AGENDA
Planning and Zoning Commission
September 16, 2026 – REGULAR MEETING
5:30 PM

MINUTES
PLANNING AND ZONING COMMISSION
TOWN OF JACKSON, WYOMING
September 2, 2026
UNAPPROVED

Meeting Date:	September 16, 2026	Meeting Title:	Planning Commission
Submitting Department:	Planning Department	Presenter:	Katelyn Page
Agenda Item:	Development Plan for a new 3-story mixed-use building at the properties addressed 655 and 665 South Cache Street (P26-058)	Public Comment:	Yes

LEVEL 1 EXTERIOR LIGHTING PLAN
SCALE: 1/4" = 1'0"

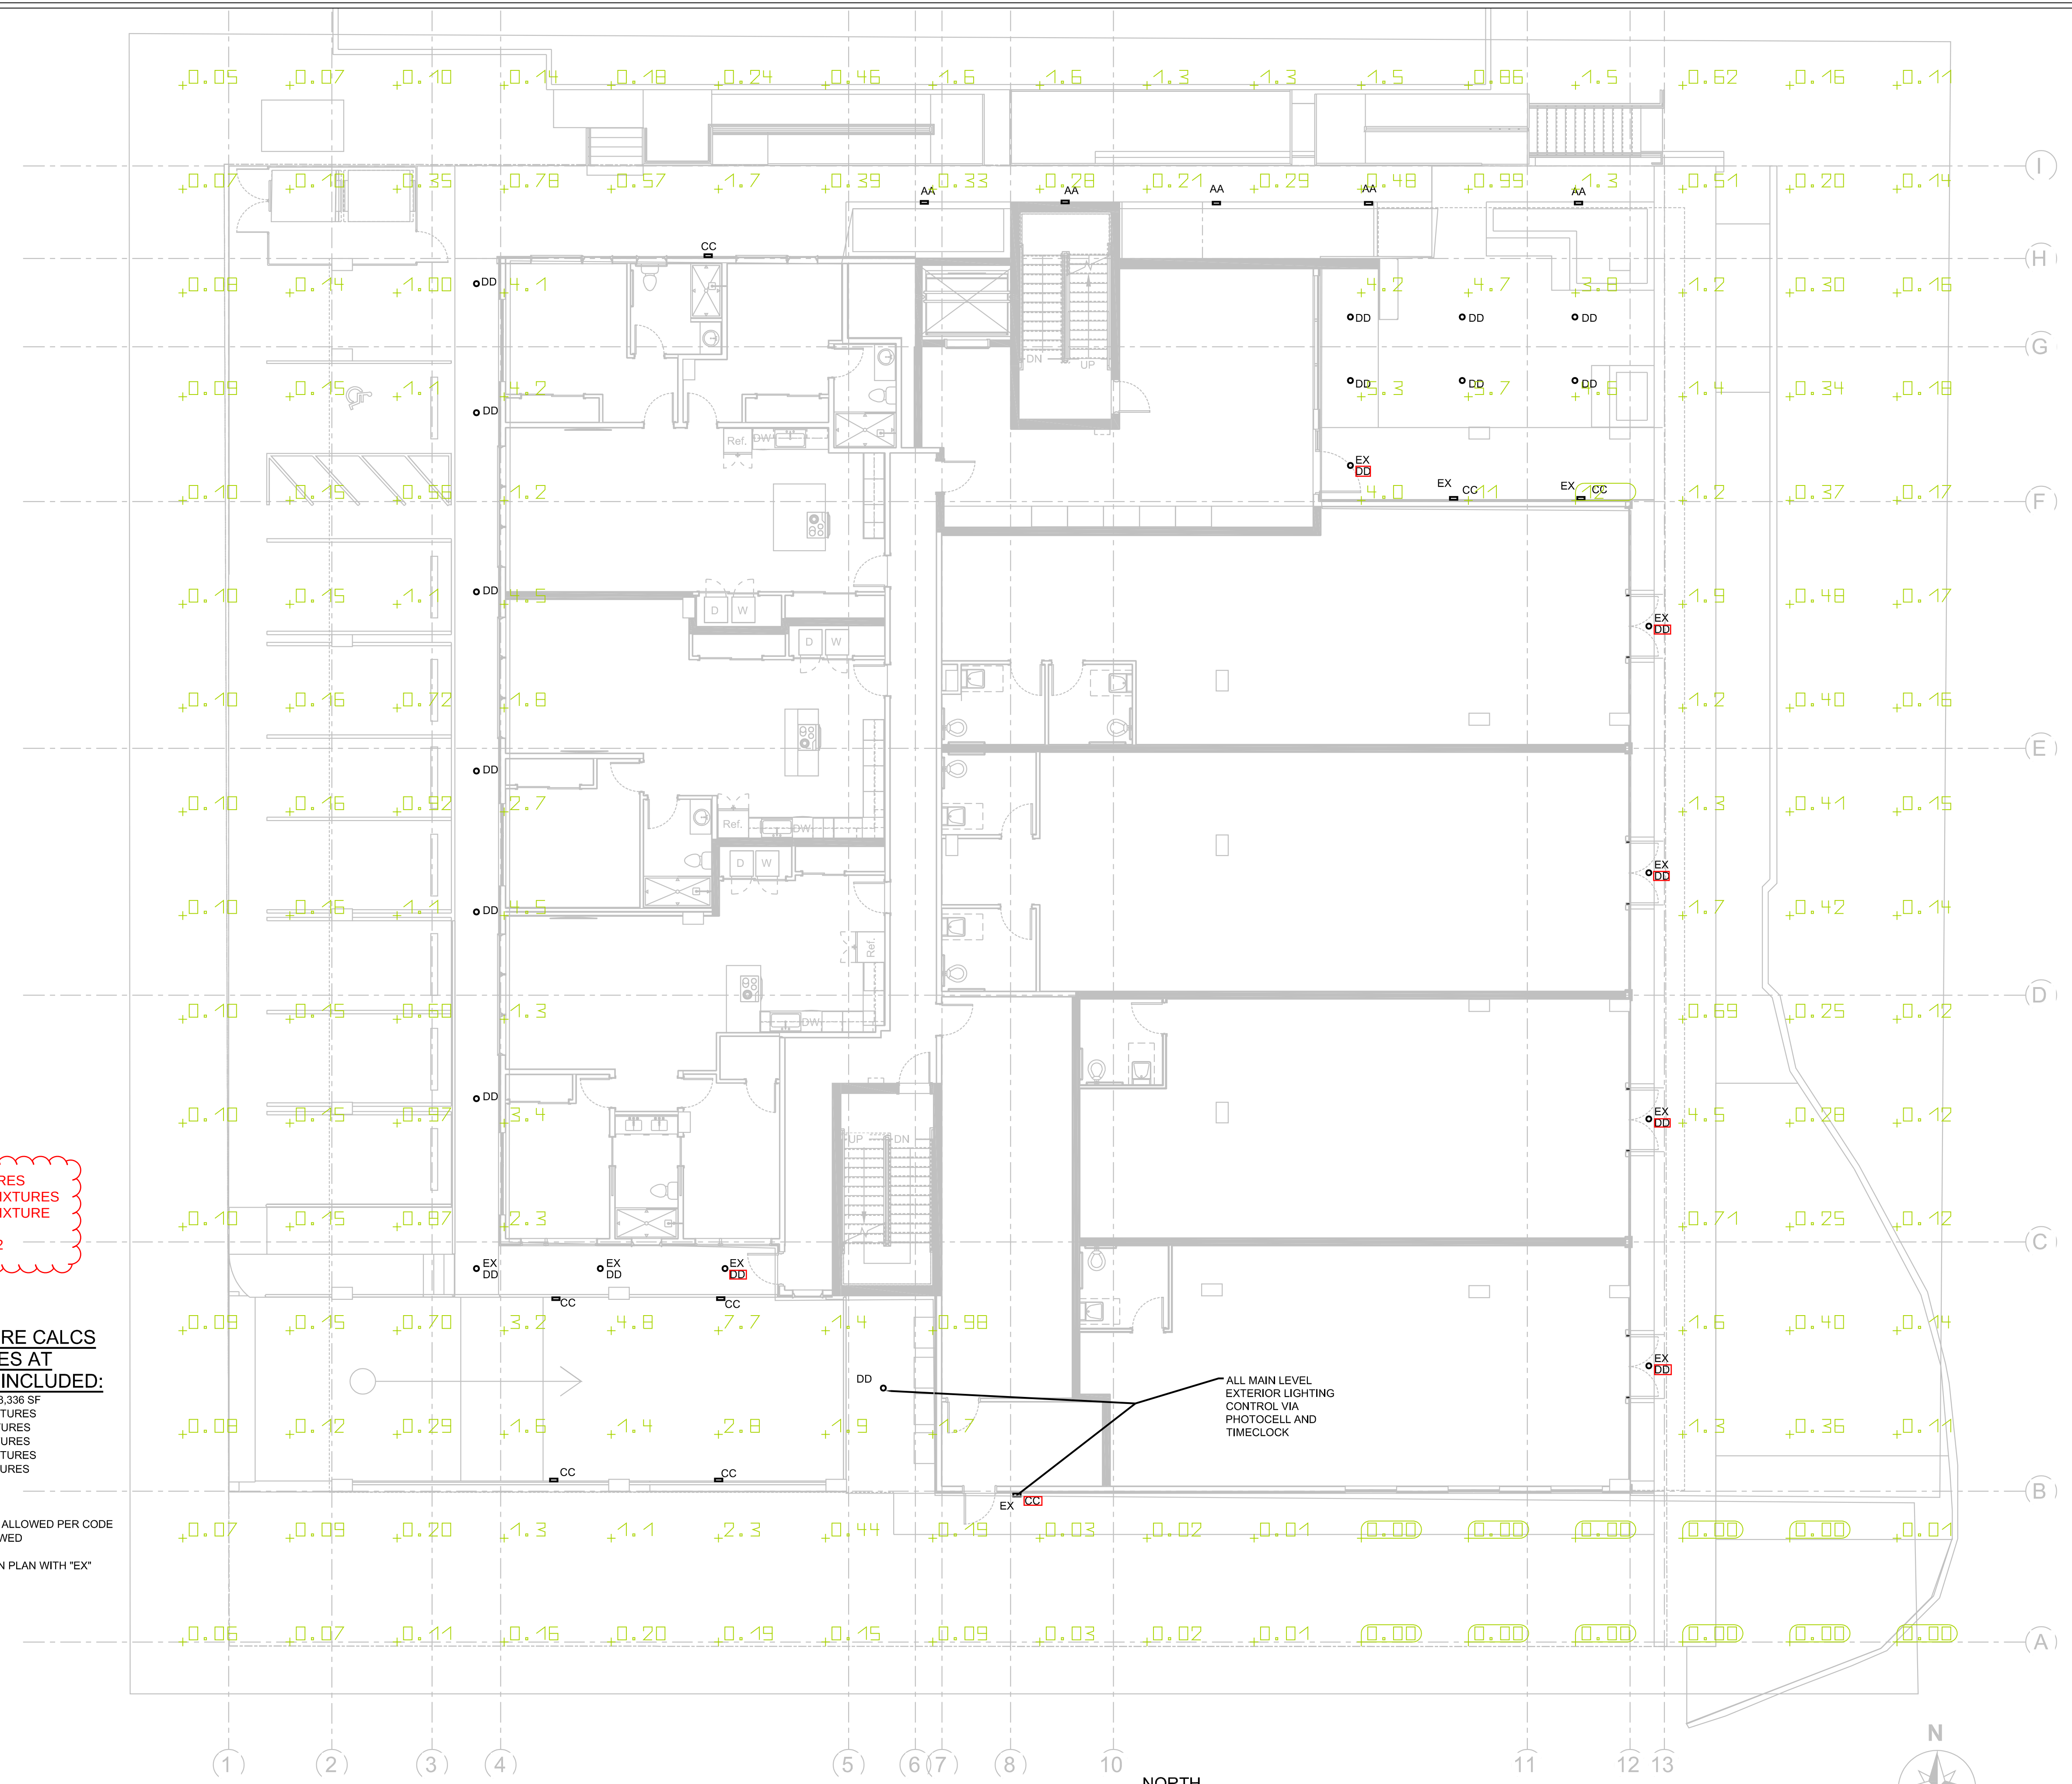
EX1.0 –Revise lighting plan to show compliance with lumen maximum. LDRs were updated in 2022 for lighting standards. Based on site acreage of 0.46, the CR-1 zone is allowed a maximum of 3 lumens per sf of site development but is limited by a maximum of 50,000 lumens per acre of site development for all fixtures and a maximum of 2000 lumens per acre of site development for unshielded fixtures. All lights over 600 lumens shall be fully shielded and light color may not exceed 3000 kelvin. Staff requires the site development area in order to confirm maximum lumens, however, it is likely it will be closer to half the amount currently proposed. Revise plans to include total amount of site development so staff may verify above lumen maximums.

SITE OVERVIEW AND UTILITIES - C3.0

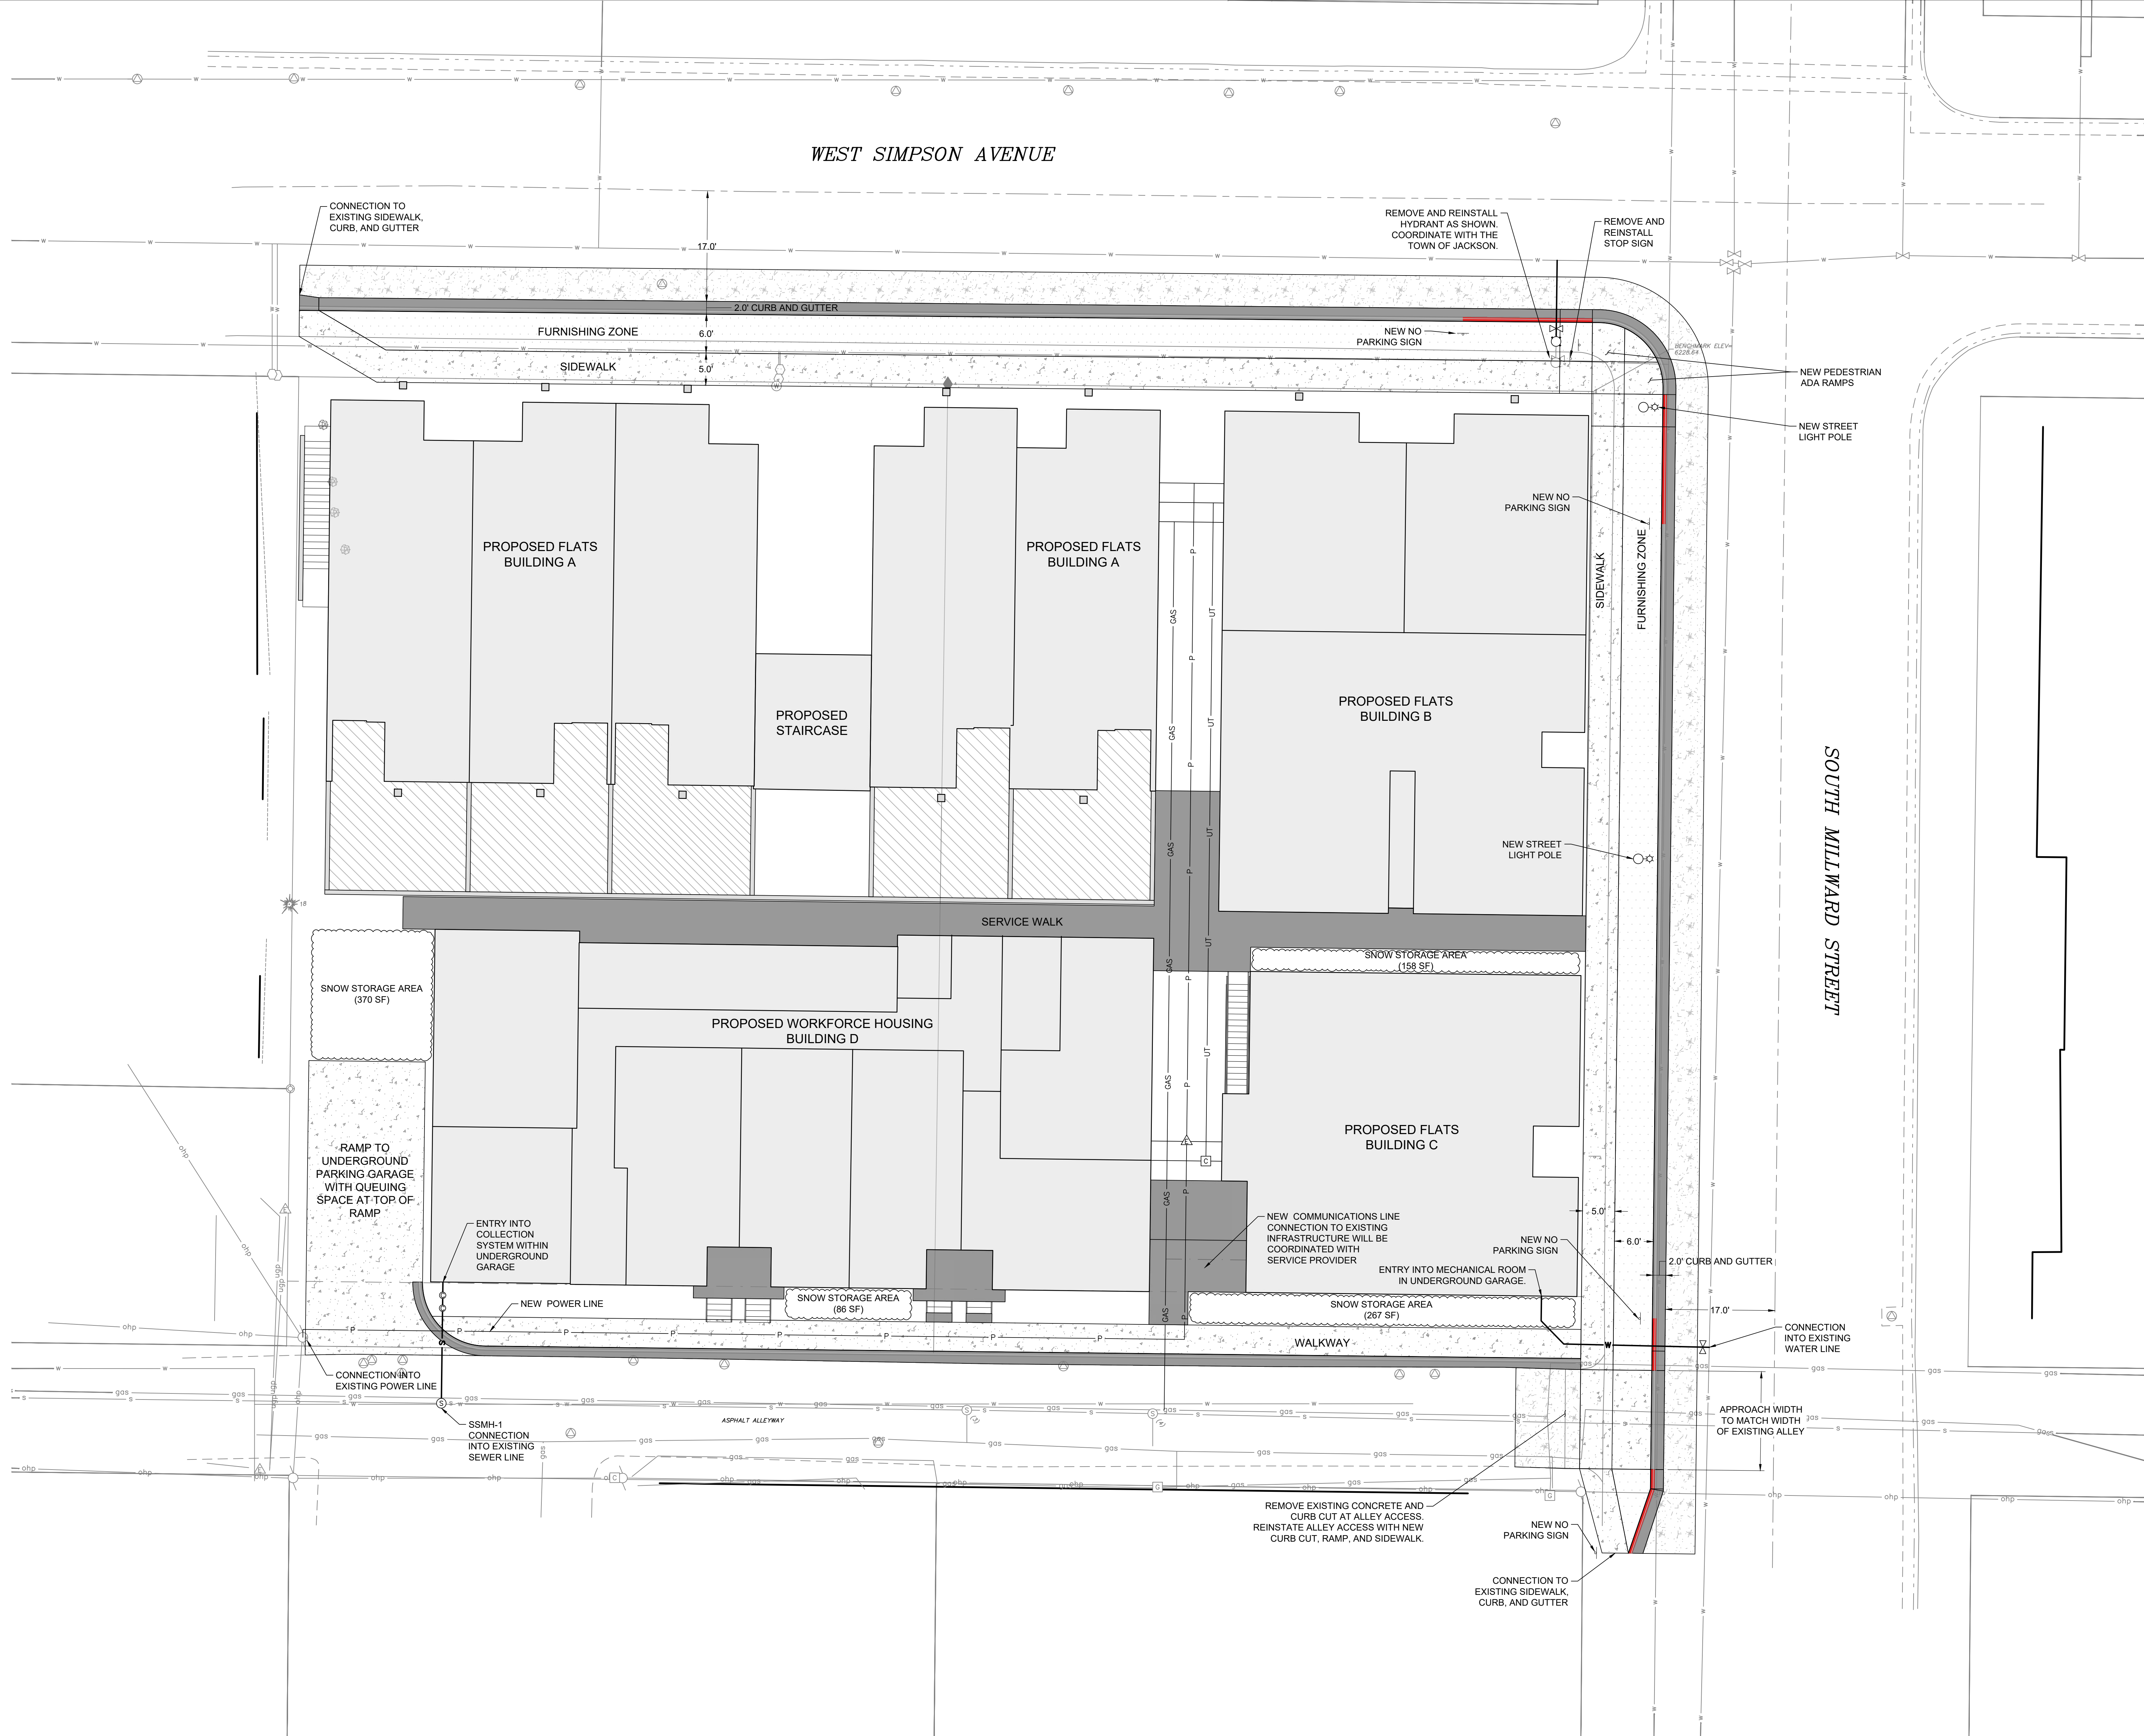
8. C3.0: Provide street cross sections of existing and proposed streets. Sections shall encompass the entire right of way width or to back of sidewalk, whichever is greater. Coordinate with Town Engineering and Pathways on dimensions. Build proposed section from the center of the right-of-way, dimension any variance in road centerline and ROW centerline. Minimum sidewalk width should be 6-feet. Ideally, the back of sidewalk is coincident with property line, otherwise apply for a sidewalk easement with building permit.

- C2.1: The existing monitoring well shown in front of Building A needs to remain. Provide a construction note to protect the well.
- C3.0: Revise note on fire hydrant relocation: Relocate hydrant to buffer strip. Town Water to assess conditions prior to relocation. Town may provide a new hydrant for installation.
